CASE CAPTION: Discuss and consider a request by Lisa Deaton of Palm Development Partners, LLC on behalf of Donna Perry of East Shore J/V for the approval of a Site Plan for a Medical Office Building on a 1.4384-acre parcel of land identified as Lot 27, Block A, The Standard-Rockwall Addition, City of Rockwall, Rockwall County, Texas, zoned Planned Development District 68 (PD-68) for Commercial (C) District land uses, situated within the SH-205 Overlay (SH-205 OV) District, addressed as 1301 S. Goliad Street [SH-205], and take any action necessary.

DEPARTMENT	REVIEWER	DATE OF REVIEW	STATUS OF PROJECT
PLANNING	Ryan Miller	10/24/2025	Approved w/ Comments

10/24/2025: SP2025-041; Site Plan for a Medical Office Building at 1301 S. Goliad Street  
Please address the following comments (M= Mandatory Comments; I = Informational Comments)

CASE NO.  
Z2025-055  
SHEET NO.  
C-4

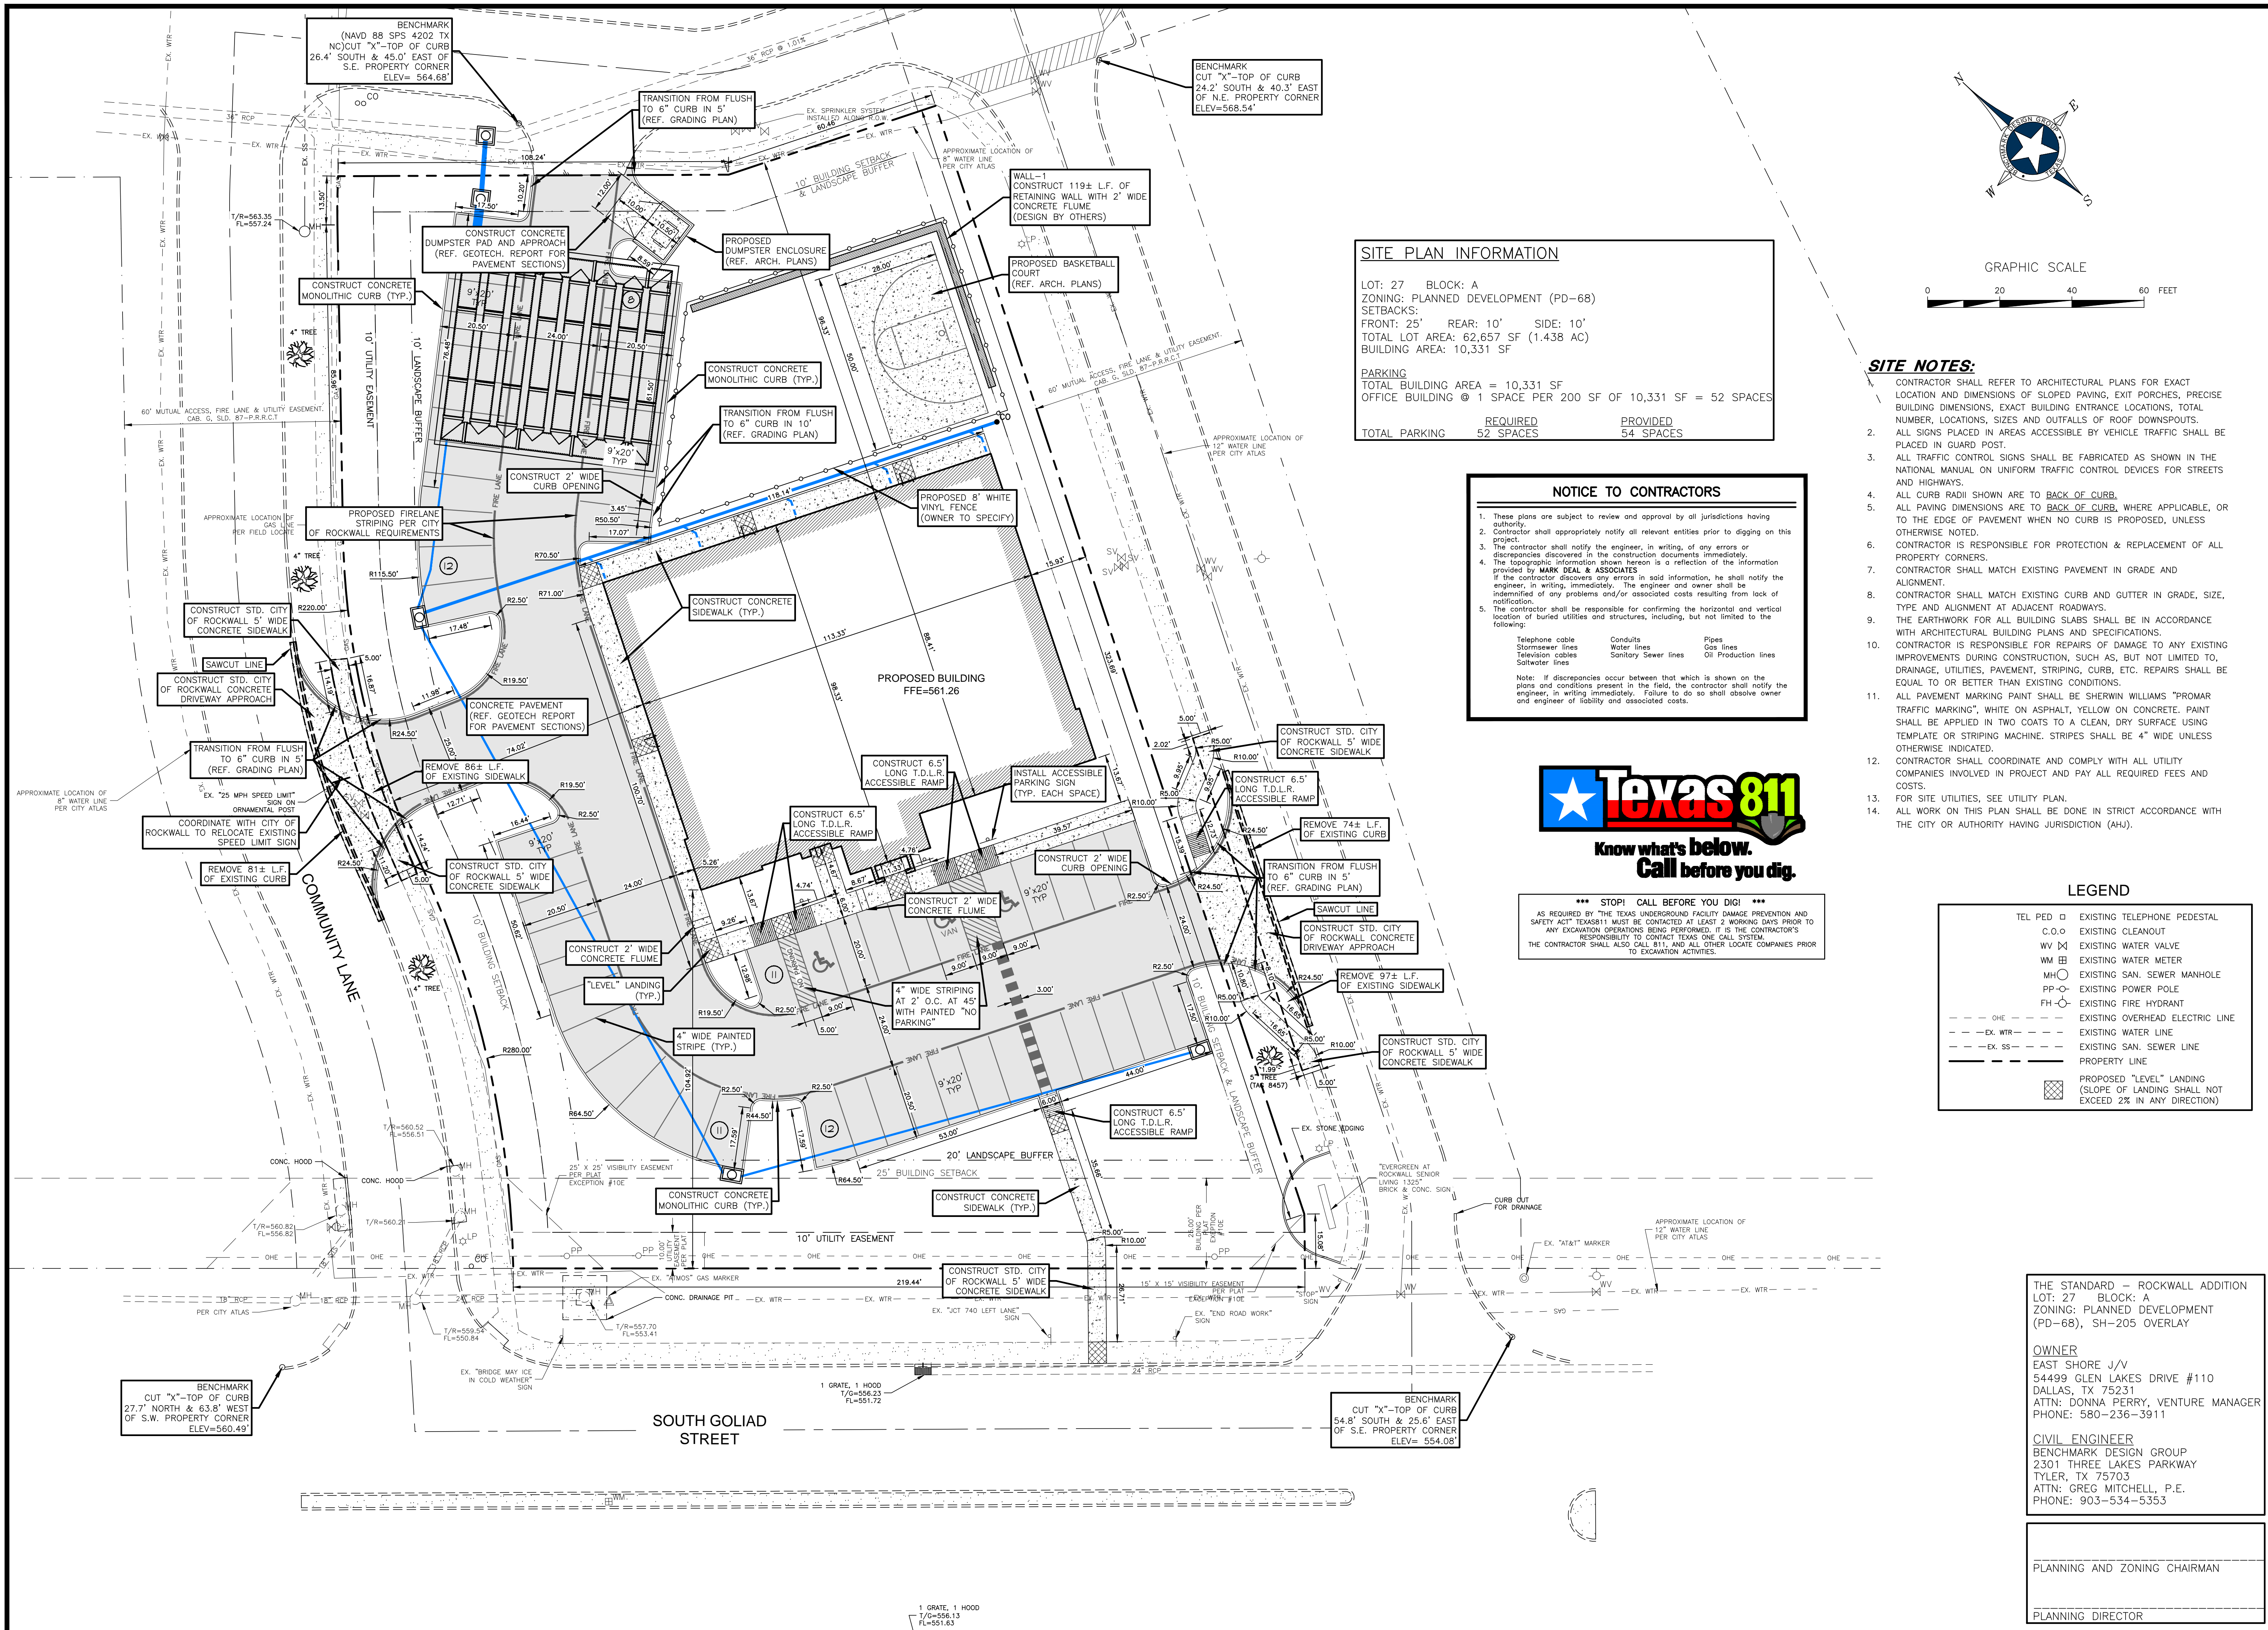
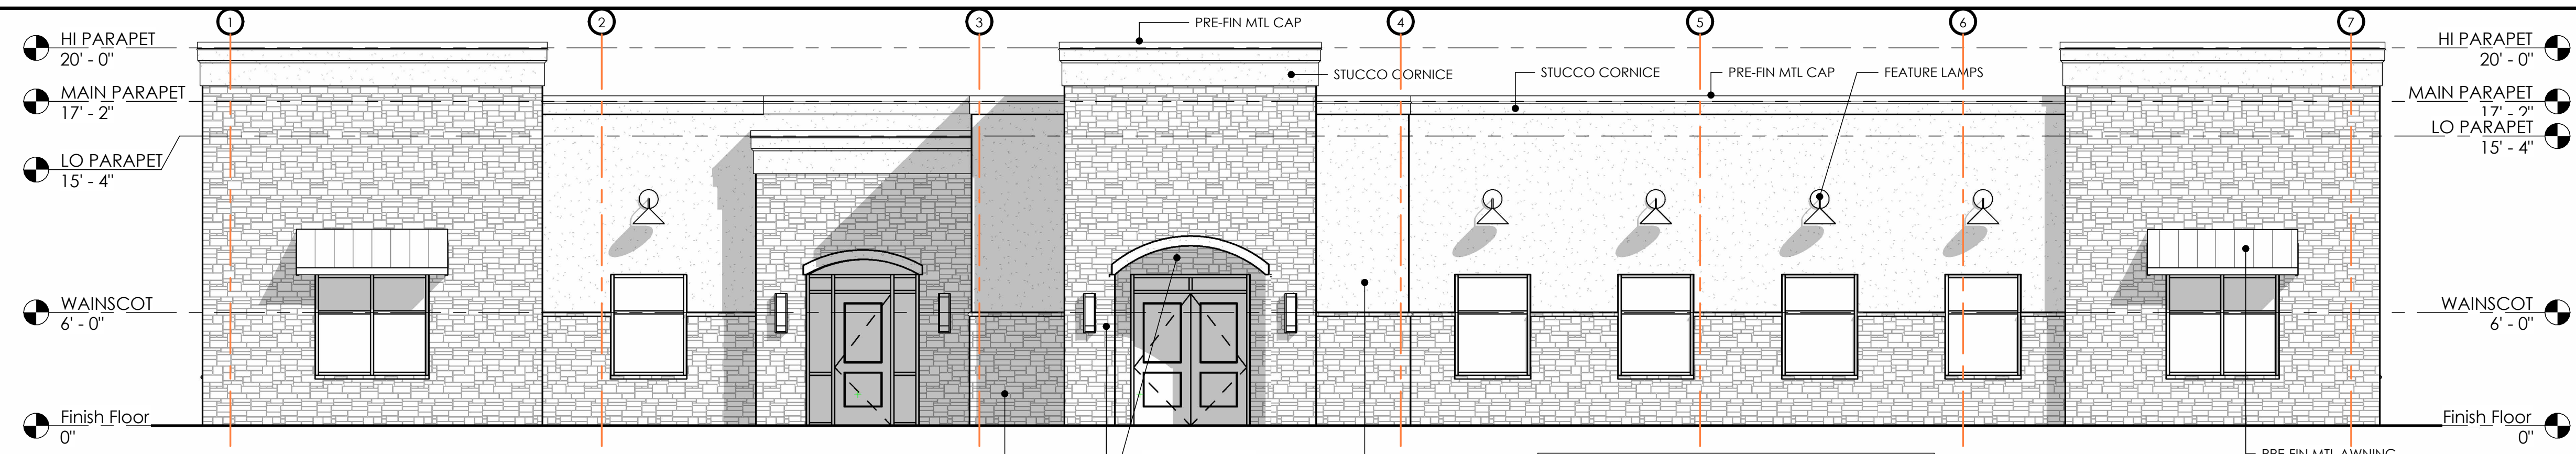
#### M.7 Site Plan.

- (1) Please provide a vicinity map that locates the site relative to the nearest major roadways in a one-half mile radius. (Subsection 03.04. B, of Article 11, UDC)

- (2) Please indicate the fire lane as Fire Lane, Public Access, and Utility Easement. (Subsection 03.04. B, of Article 11, UDC)
- (3) Indicate the type and depth of the paving material and provide a detail or cut-sheet. (Subsection 03.02, of Article 06, UDC)

- (4) Signage is done through separate permits with the Building Inspections Department. (Subsection 06.02. F, of Article 05, UDC)
- (5) Please indicate any existing or proposed fencing. Please delineate the location and provide the material and height. (Subsection 08.02. F, of Article 08, UDC)

- (6) All pad mounted equipment must be shown on the site plan. This equipment must be screened with five (5) gallon evergreen shrubs, which should be shown on the landscape plan. (Subsection 01.05.C, of Article 05, UDC)

- (7) Please provide a note that there shall no above ground storage tanks or outside storage, which includes vehicles. (Subsection 01.05. B, of Article 05, UDC)

**1 SOUTH / FRONT ELEVATION**  
SCALE: 3/16" = 1'-0"

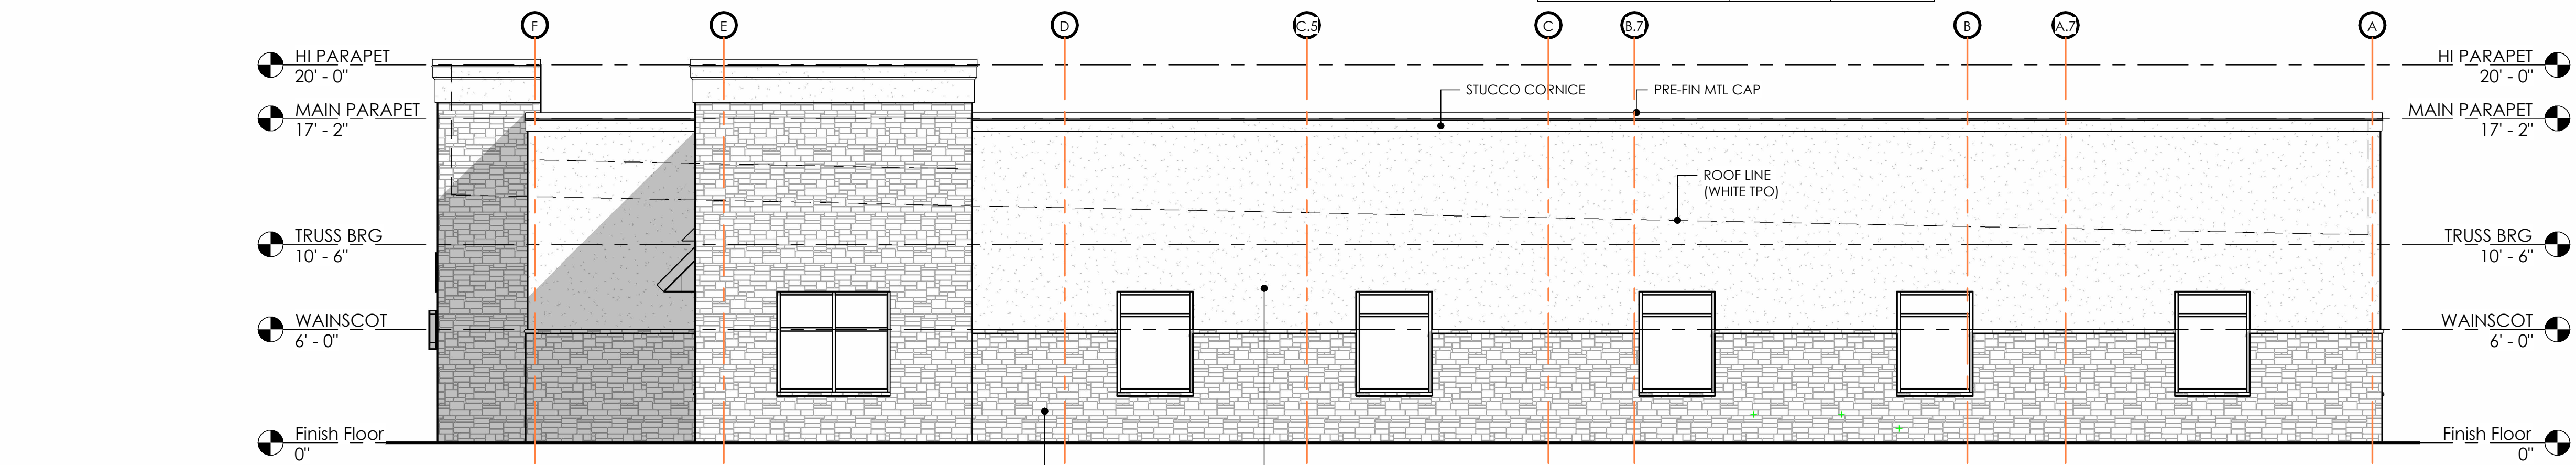
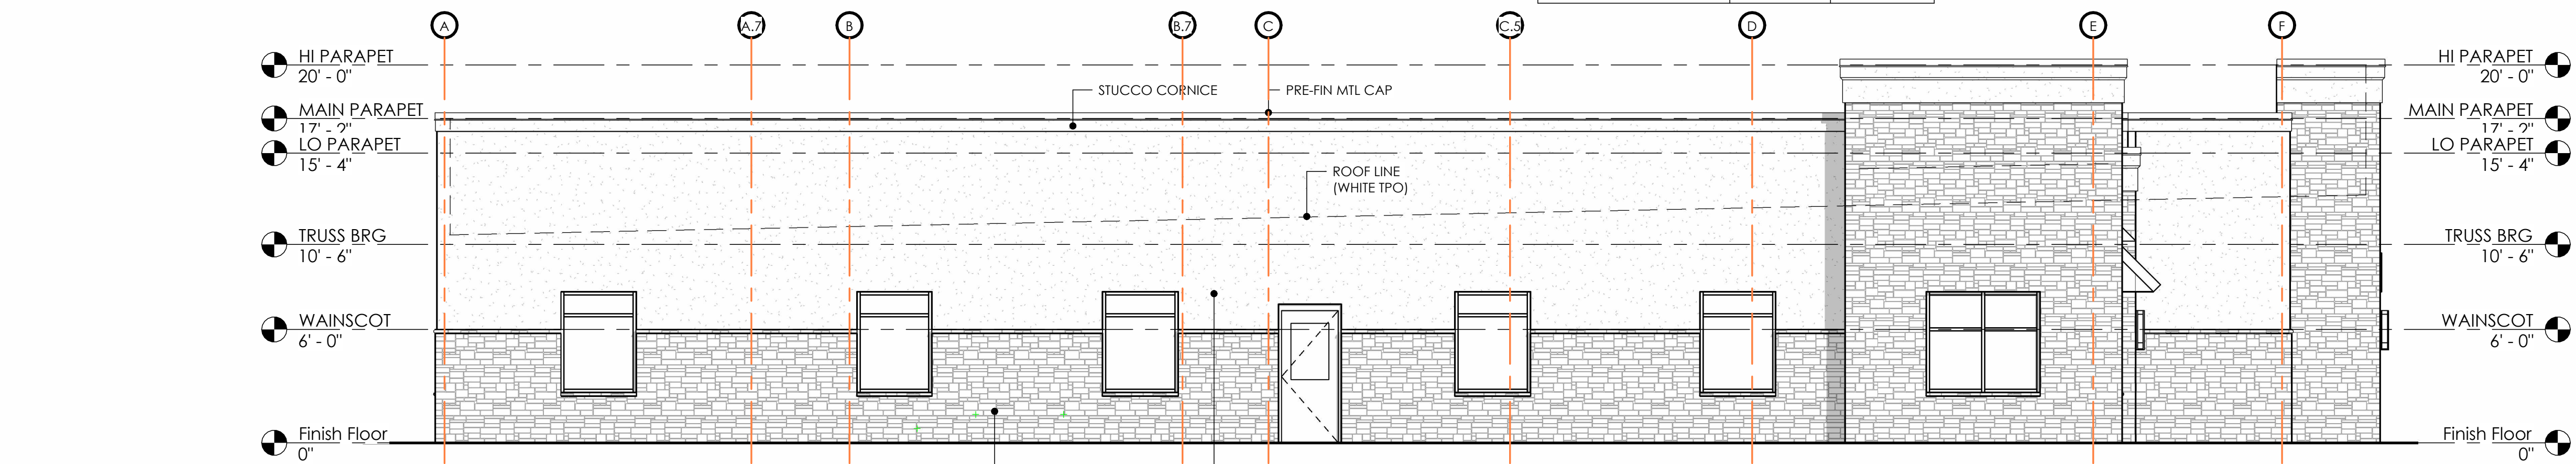
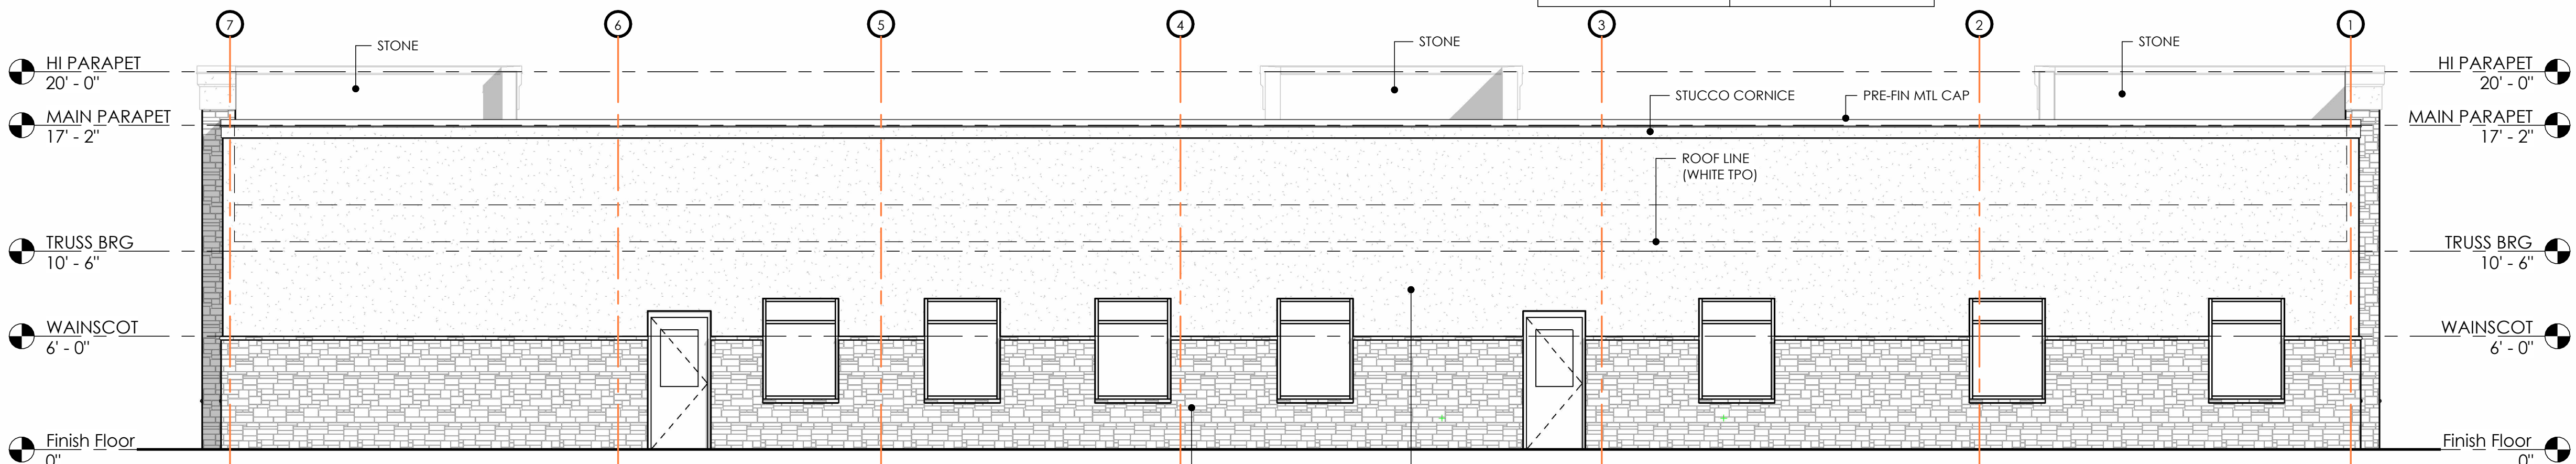
- (3) The subject property is located within an Overlay District. This requires that each façade cannot utilize more than 50% cementitious material. In this case, the north and east façade exceeds this requirement. Please correct this or this will be a Variance request. (Subsection 06.02, of Article 05, UDC)

- (7) The subject property is located within an Overlay District. This requires four (4) sided architecture where all sides of the building must utilize the same materials, detailing, articulation and features. In this case, the detailing, features, and articulation are not the same on each side. Please provide four (4) sided architecture or this will be a Variance request. (Subsection 06.02, of Article 05, UDC)

- (8) In addition, the comment above, the four (4) sided architecture requires the primary articulation standards to be used on each side of the building. Please see the areas of non-conformance below. Please correct this or this will be a Variance request. (Subsection 06.02, of Article 05, UDC)
